VILLAGE OF KIMBERLY, WI
NOTICE OF VILLAGE BOARD MEETING

**Village of Kimberly
Request for
Plan Commission Recommendation**

ITEM DESCRIPTION: Aspire Phase 2 Site & Building Plan Review

Re: Site Plan & Stormwater Management Plan Review
Aspire-Phase II (Heritage-MSP Kimberly)
McM. No. K0001-09-24-00338.04

1 ARCHITECTURAL SITE PLAN
1" = 30'-0"

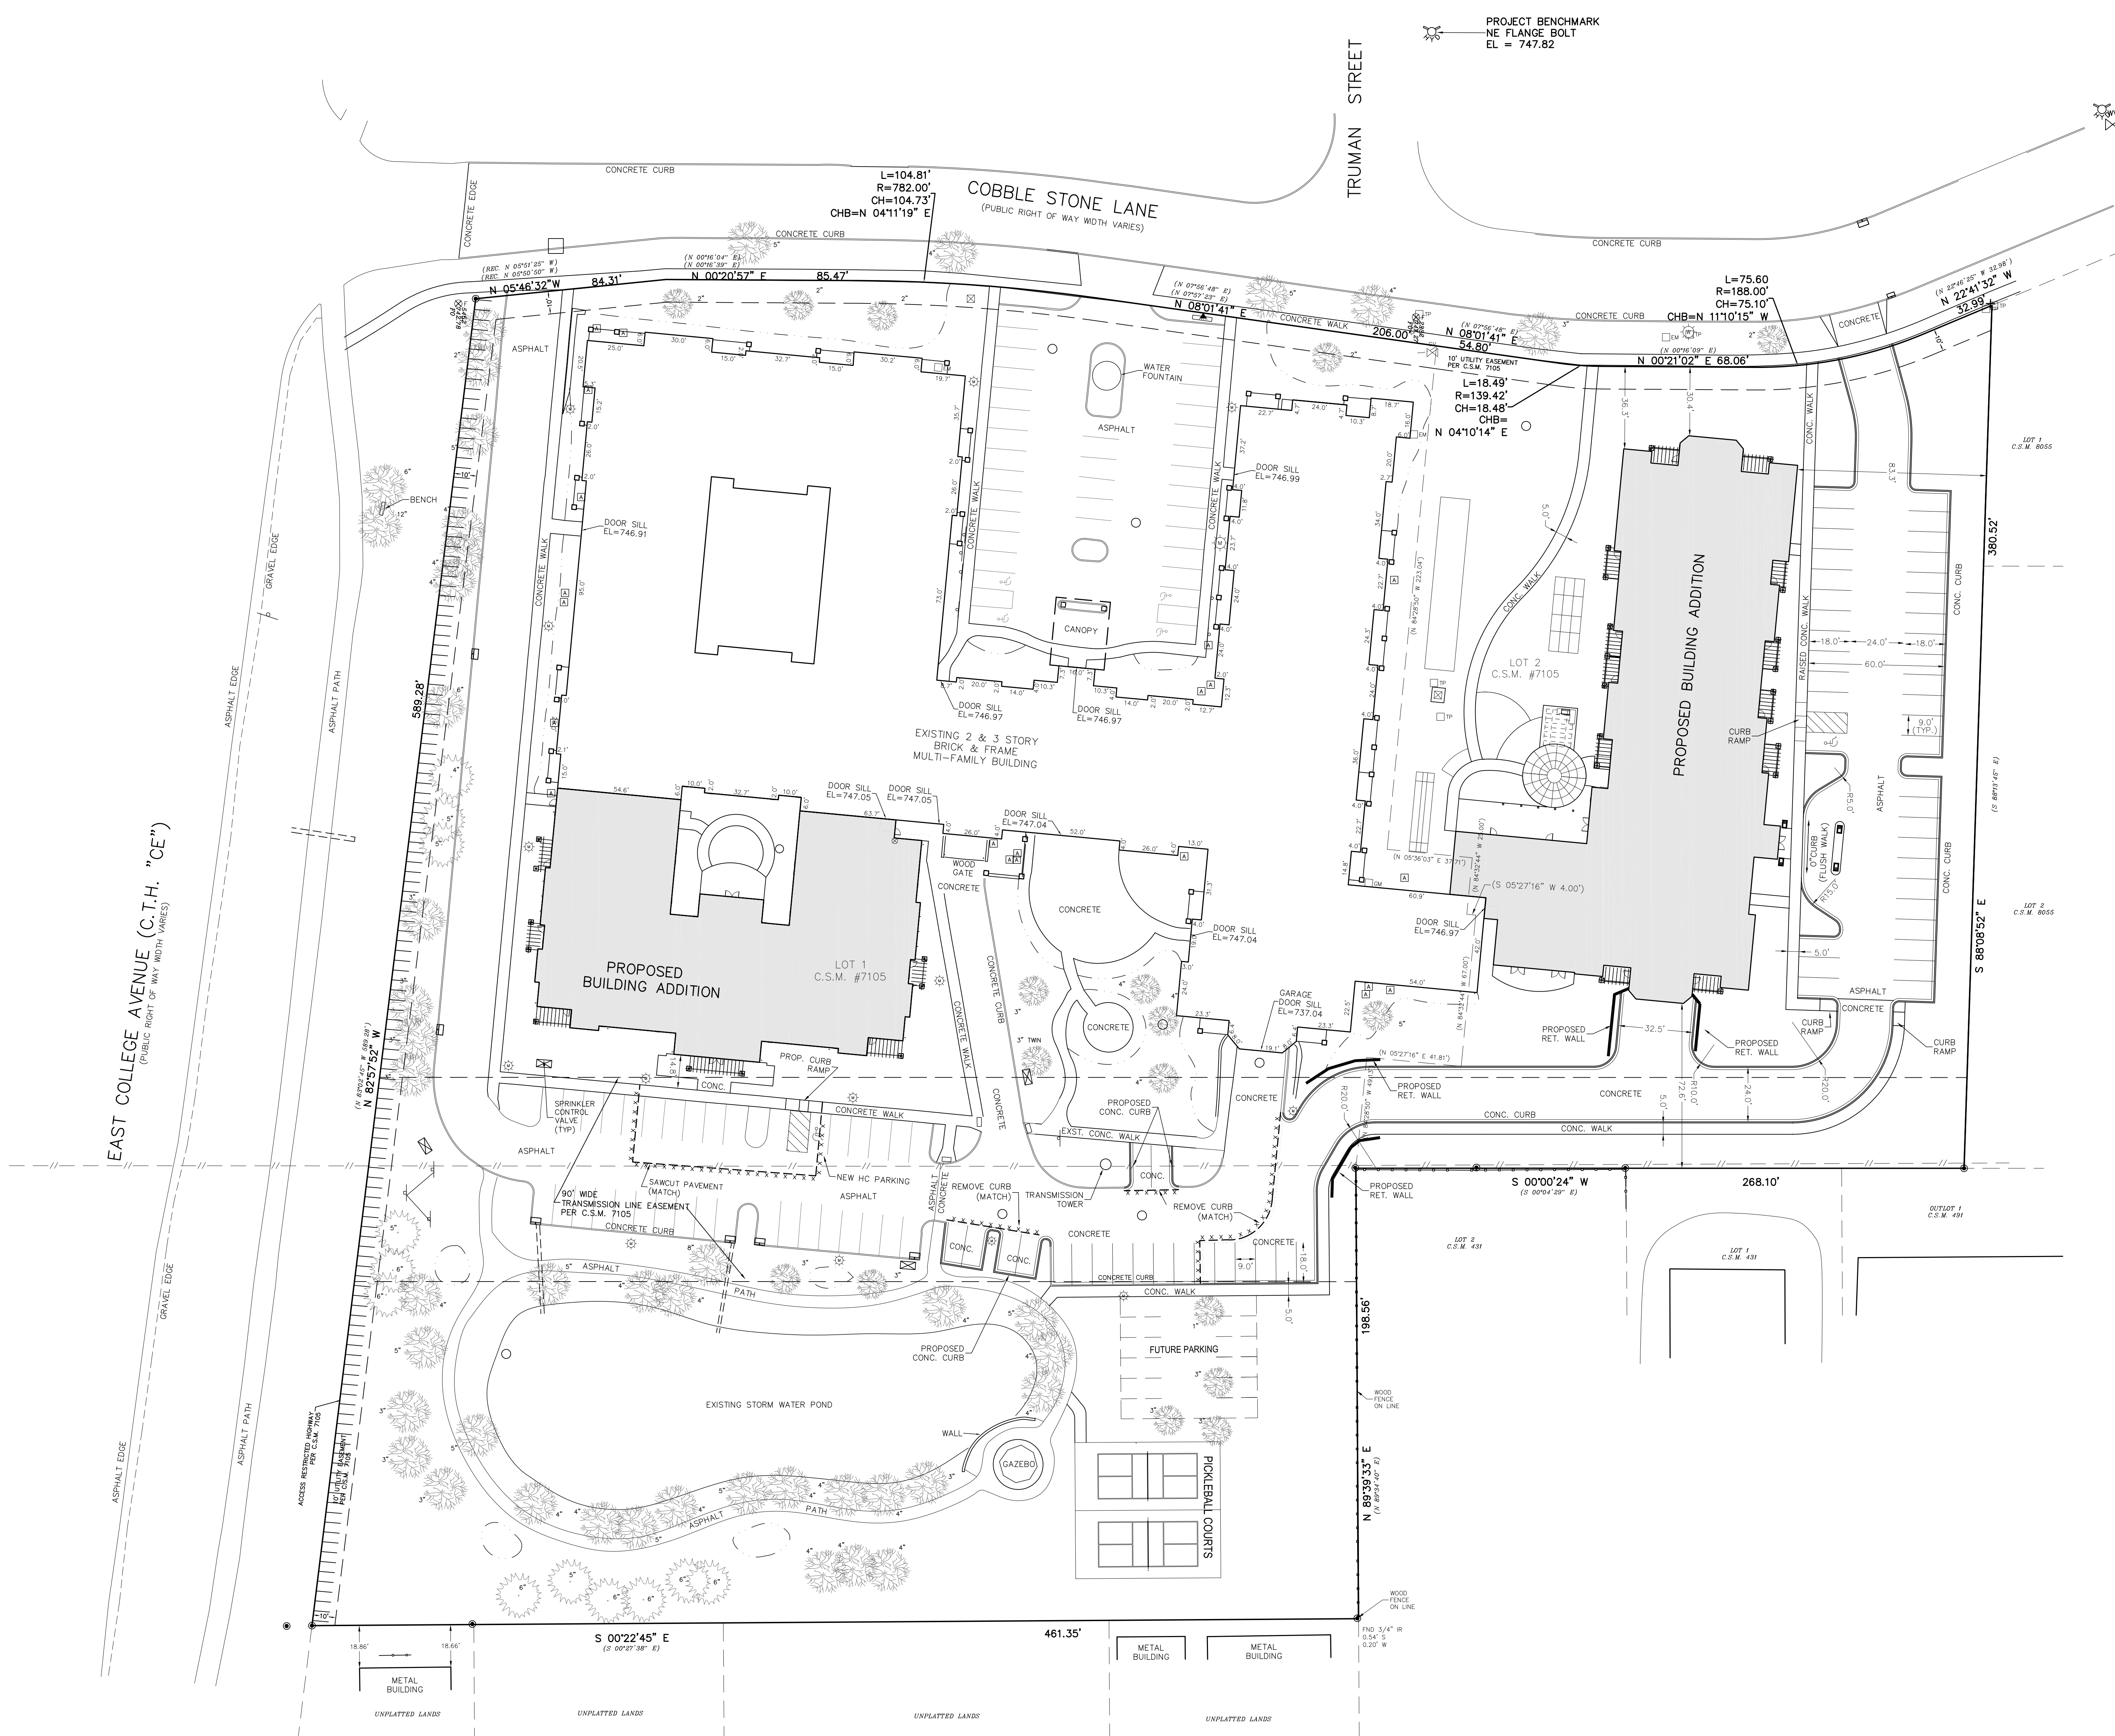
- Setbacks** – compliant.
- Parking** – No setbacks required. Complaint with municipal code requirements. See top right corner of “Site Plan Review Submittal” plan set. Historic on-street parking concerns, therefore staff is requesting additional stalls added to the most north-western lot. See review comments.
